13 December 2022

NSW Health Infrastructure  
1 Reserve Road  
ST LEONARDS NSW 2065

**RE: COWRA HOSPITAL –REF WORKS  
LIVERPOOL & BRISBANE STREET, COWRA NSW 2794  
BCA / ACCESS COMPLIANCE STATEMENT FOR REF SUBMISSION**

Ground Floor

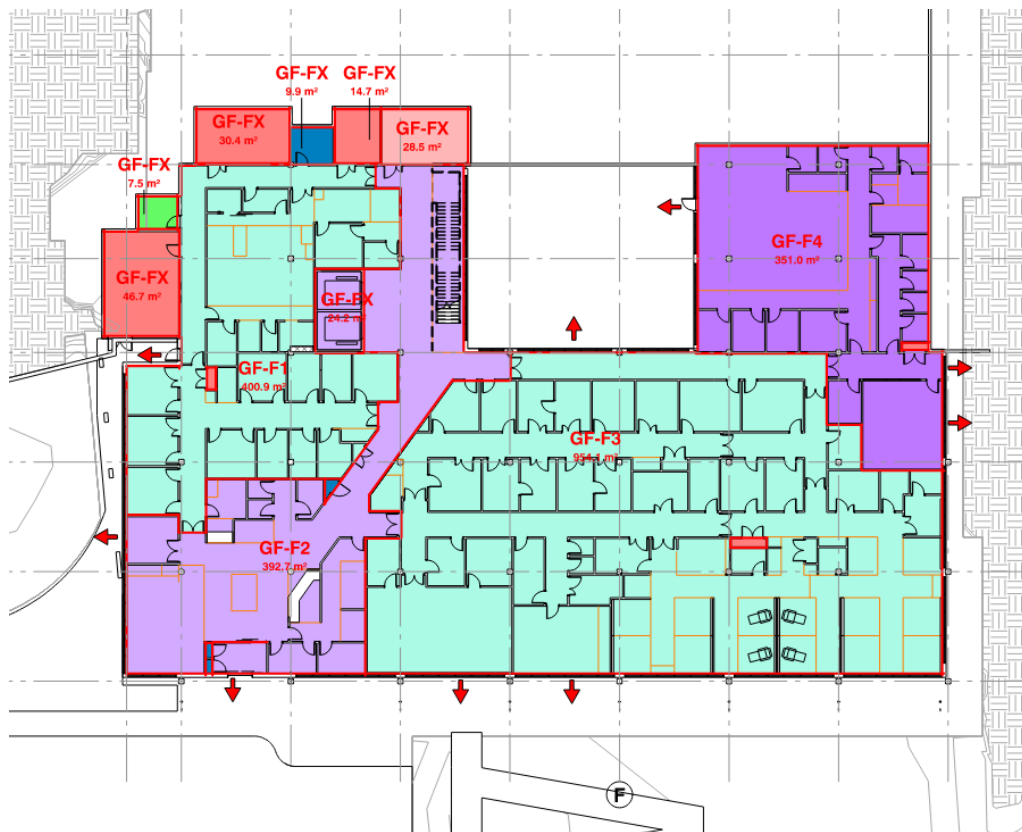
The location of fire and smoke walls will need to consider two factors; separation of treatment areas, and the provision of horizontal exits (through the inclusion of 2-hour fire walls) to bring egress distances into compliance or towards the acceptable limits of fire engineering. Furthermore, consideration has been placed on future proofing the location of fire/smoke walls and the sizing of compartments.

Compliance is readily achievable and the location of these walls will be developed during the design, noting the two respective buildings will have fire walls separating the pedestrian links that connect the adjoining buildings.
C3.3	<u>Separation of external walls and associated openings in different fire compartments:</u> Exposure between adjacent fire compartments occurs for each building. <i>Compliance will be met through consideration under a fire engineered performance solution in this instances</i>
C3.15	<u>Openings for Service Installations:</u> Where service installations penetrate the walls or floors required to have an FRL with respect to integrity and insulation they are to be protected by fire seals having an FRL of the building element concerned. Fire seals are required to comply with Specification C3.15, or be identified with a prototype of a system tested to AS 1530.4.
Spec C1.1	<u>Fire-Resisting Construction:</u> The building is required to comply with Table 5 as relevant to FRLs required for buildings of Type C Construction. This will generally require 2-hour FRL to all fire walls (separating from adjoining buildings). 2 hour FRL will be required only where external walls are exposed to adjoining buildings (or part) less than 6m.  The FER will need to acknowledge these two buildings as separate buildings for the purpose of the BCA.

### Ground Floor

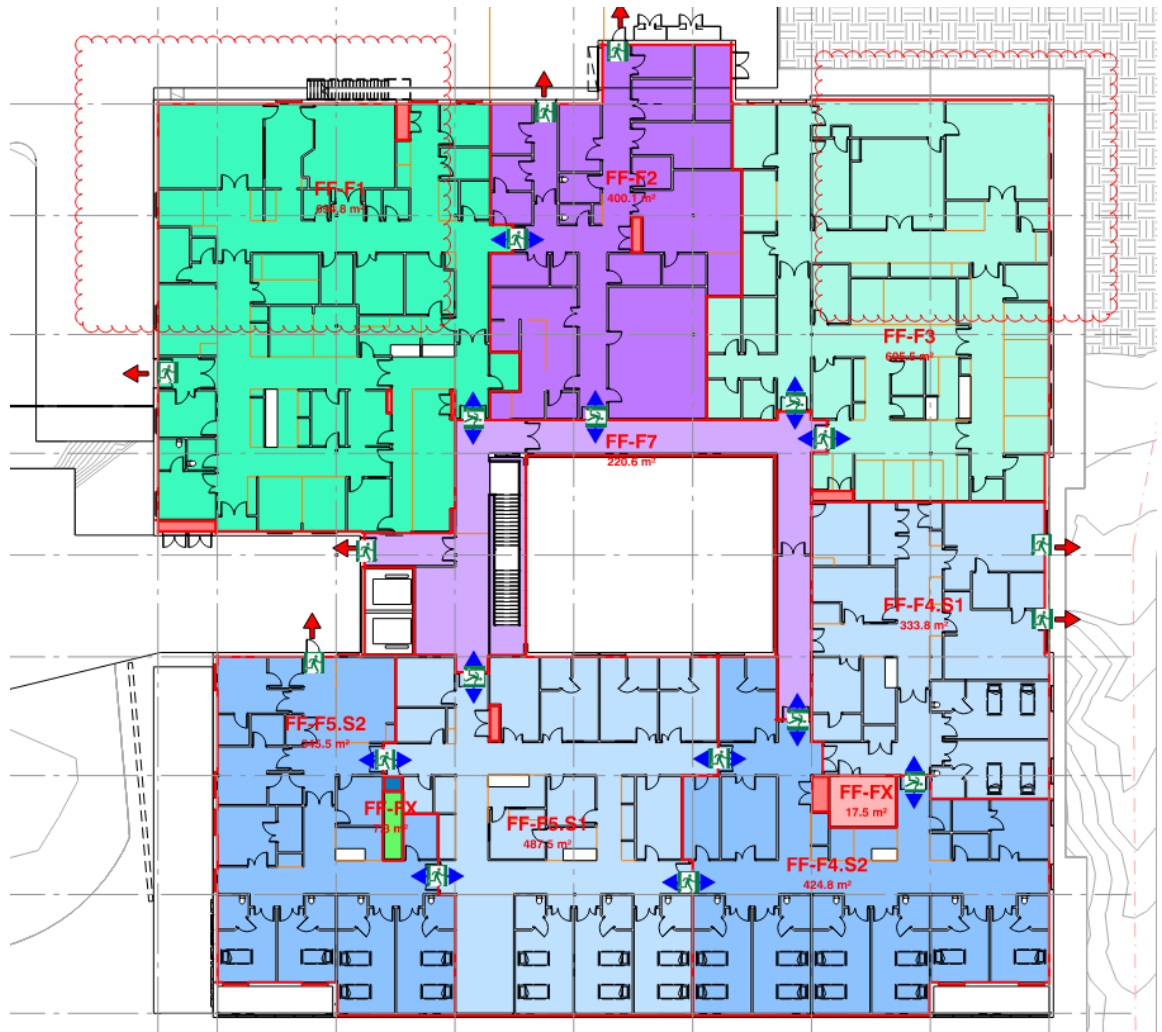
Egress within the zone clouded above will be further refined to comply during scheme design development.

Travel distances within the zones clouded above are to be further refined to achieve compliance during scheme design development.
